**CALIFORNIA COASTAL COMMISSION**

**STAFF REPORT: PERMIT AMENDMENT**

**APPLICATION NO: A-4-STB-93-154-A-2**

**DESCRIPTION OF AMENDMENT:** Modify a number of existing elements of the golf course including layout of fairways putting greens and driving range, tees, cart paths, vehicular entrances, location of storage lake, architectural design of buildings, drainage design, future horse tie-up/bicycle rack; location and number of bridges. Add a pump house, a six-acre parcel to the project site; and concrete terminus to the vertical access west of Tomate Canyon. Revise the project description to reflect proposed changes and to conform to previously included elements in design plans.

ORIGINALLY APPROVED GOLF COURSE PLAN

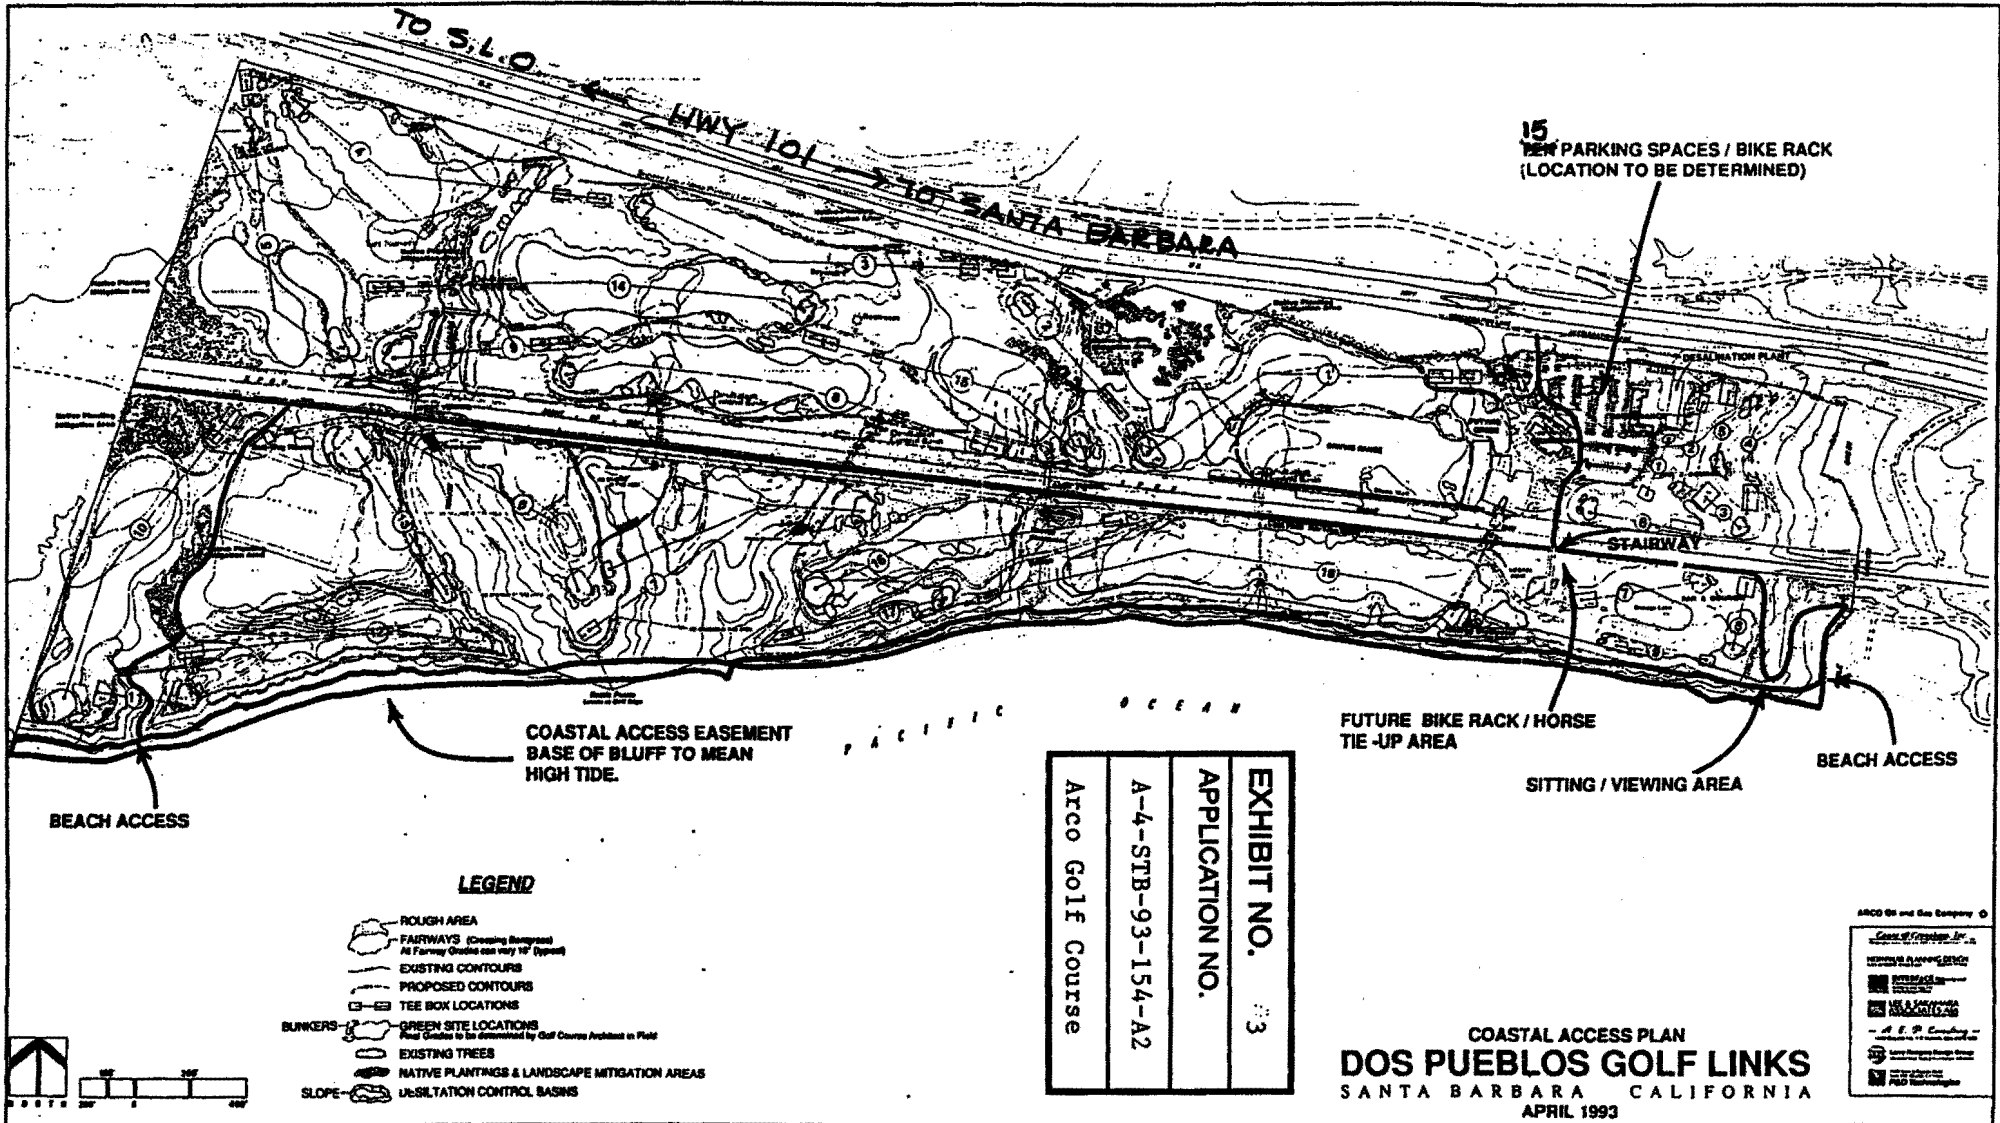
Basically, the proposed amendment changes are intended to avoid impacting coastal resources (including seasonal wetlands) which have expanded or shifted location in response to the naturally dynamic nature of the site. The other changes are intended to address aesthetic or other design issues. None of the changes fundamentally alters the project originally approved by the Coastal Commission in 1994. These changes are further described below.

**PARTIAL SITE PLAN OF CLUBHOUSE AREA**  
 SEE LANDSCAPE PLANS FOR FINISH LAYOUT AROUND CLUBHOUSE

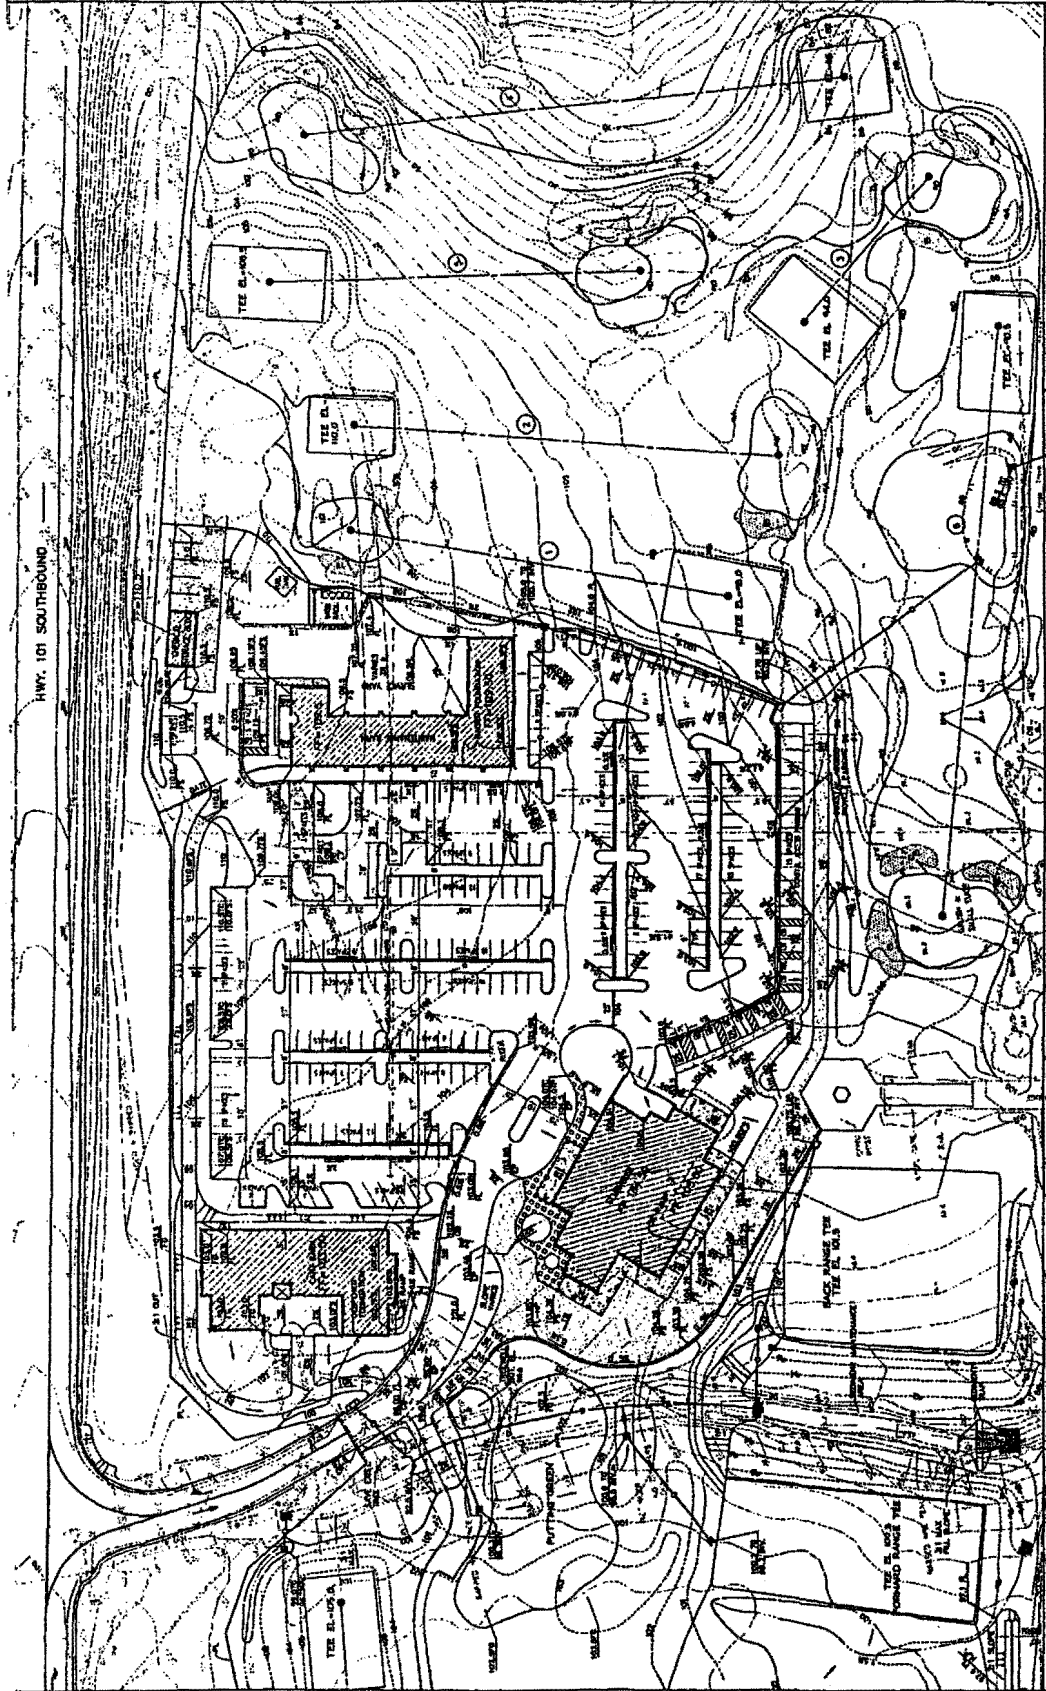
Paths and concrete walkways around the clubhouse, cart barn, and parking lot have been modified to reduce the overall amount of hardscape area, and improve on-site circulation.

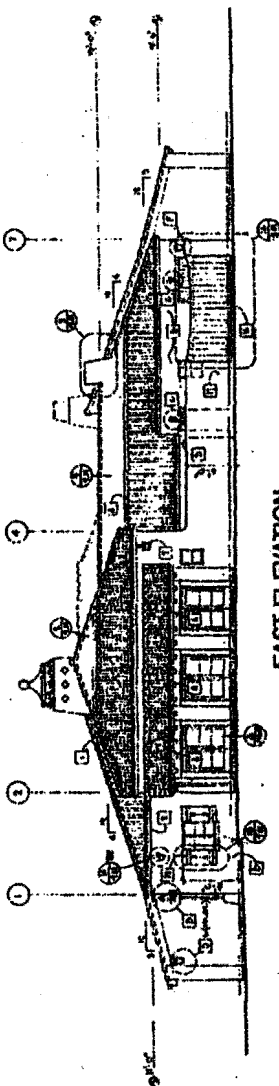
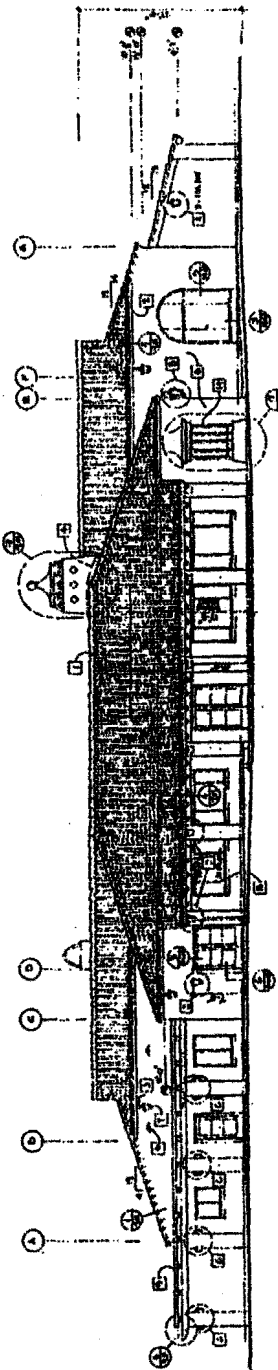
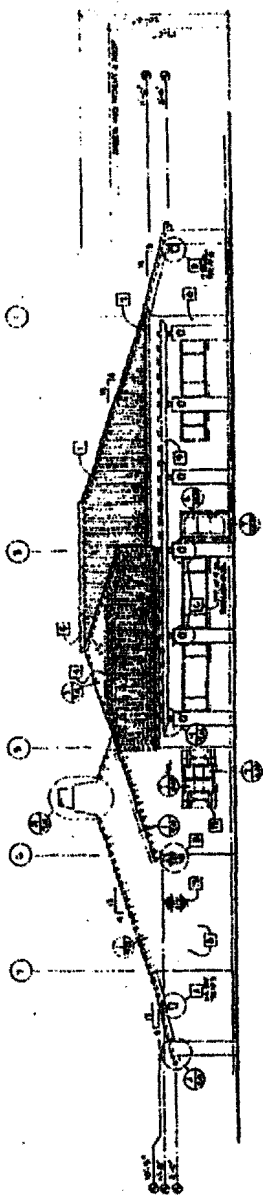
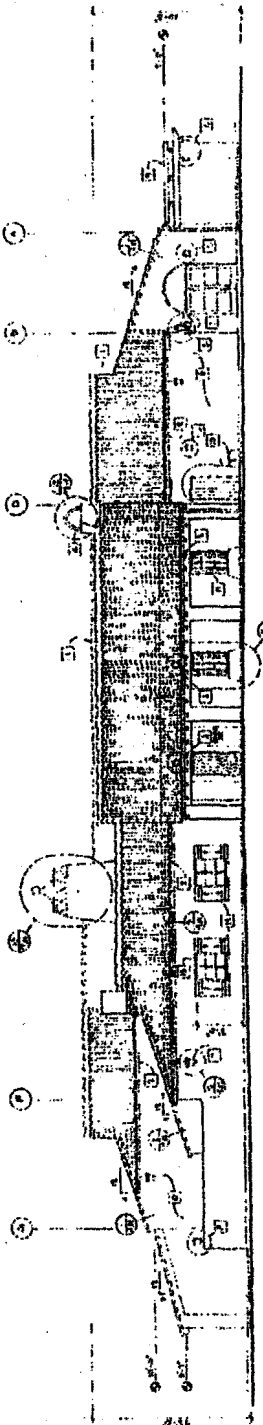
5. **Atrium:** The atrium of the building plans has been eliminated as part of the architectural design changes.
6. **Lake volume:** The original project description indicated that the water storage lake had a volume of 4 acre feet, while Special Condition #10 of the Conditional Use Permit (91-CP-085) correctly estimated the lake to be approximately 5 feet. The modifications described above do not substantially change this lake volume.

None of the changes increases the height or the floor area of the already permitted buildings, nor do they require additional alteration of landforms. In one case (the elimination of the atrium) the building height has been slightly reduced. The addition of the pump house will add a single story structure necessary for the use of the lake as a water supply. The small size and height of this structure is consistent and compatible with the other structures previously approved as part of the original Coastal Development Permit for the project. As such, it will not have any significant adverse impact on the scenic and visual quality of the site or the surrounding area.
